CITY OF LOWELL

*Request to lease street gas mains
pressure regulator stations and
make SCADA System in the area of
In City Council intersection West Sixth St.
Lowell St.*

Review of Utility Company Request for New Conduit/Pole Location

Reason Reconstruction of gas pressure regulator station, associated piping, and installation of a SCADA system to comply with the latest National Grid safety standards

GRS-LOW-189726 M-001

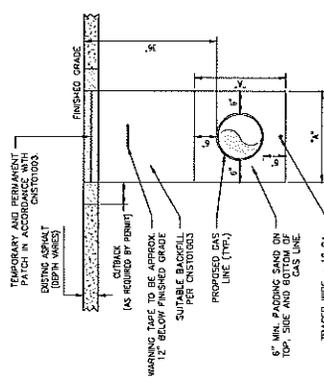
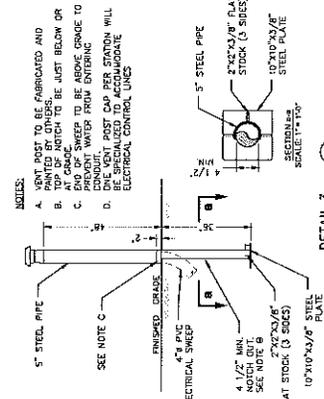
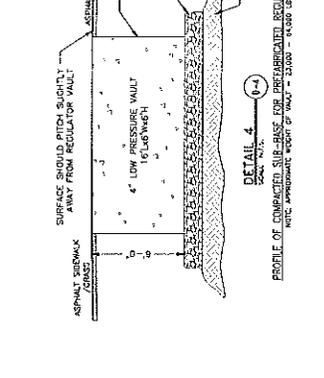
1. Refer to the attached revised plan that shows shrubs placed around the SCADA system and a flag pole and spot light installed in lieu of a tree replacement. These additions were requested by the Centralville Neighborhood groups. Flag pole installation and materials shall be coordinated with Engineering. Flag pole height shall be less than 16'.
2. Contractor shall notify adjacent property owners at least 72 hours prior to beginning work.
3. Contractor to mulch disturbed area
4. Type of shrubs around SCADA system to be coordinated with the City of Lowell
5. Restore any disturbed pavement markings
6. Pavement restoration requirements attached. Concrete panels to be replaced in full and per ADA compliance where feasible. West Sixth Street under moratorium. Any cuts into pavement require curb to curb restoration.
